STONEY CREEK STRUCTURE
GENERAL LAYOUT
KING'S HIGHWAY #129 DIST. N° 18

Stoney Creek Structure (17.0 miles N. of Sec. Hwy. 554), Hwy. 129
Site No. 38S-9, W.P. 14-74-05
Dist. #18 (Sault Ste. Marie)

FOUNDATION INVESTIGATION REPORT FOR
PROPOSED BRIDGE REPLACEMENT
STONEY CREEK - HIGHWAY 129
WP 14-74-05

We present the following comments on the Preliminary Bridge Plan Drawing 38S-9-P1 received for the above mentioned structure.

GRANULAR BACKFILL DETAILS

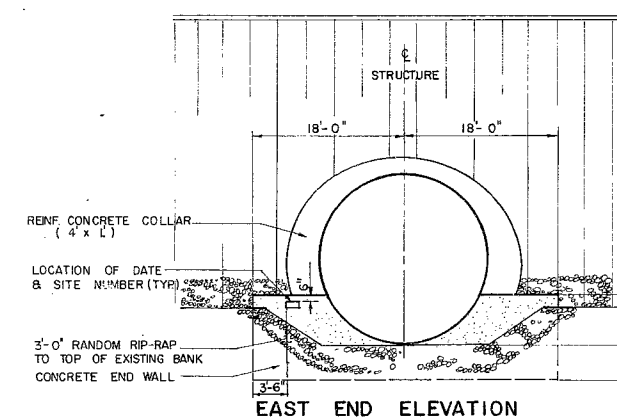
The bridge plan drawing indicates that the bedding for the 20'-0" ϕ structural plate pipe to be Screened Granular 'A'. We are not aware of this term, and it is believed that this material is Granular 'A' as per Standard No. DD-808-A, Type 2.

- (a) Unwatering is feasible and an unwatering item will be provided in the contract.
- (b) As construction will be carried out in the dry the need for Screened Granular "A" Backfill is no longer required. Granular "A" as per MTC specifications will be called for.
- (c) Tremie concrete in the end walls is to be revised to normal concrete placed in the dry.
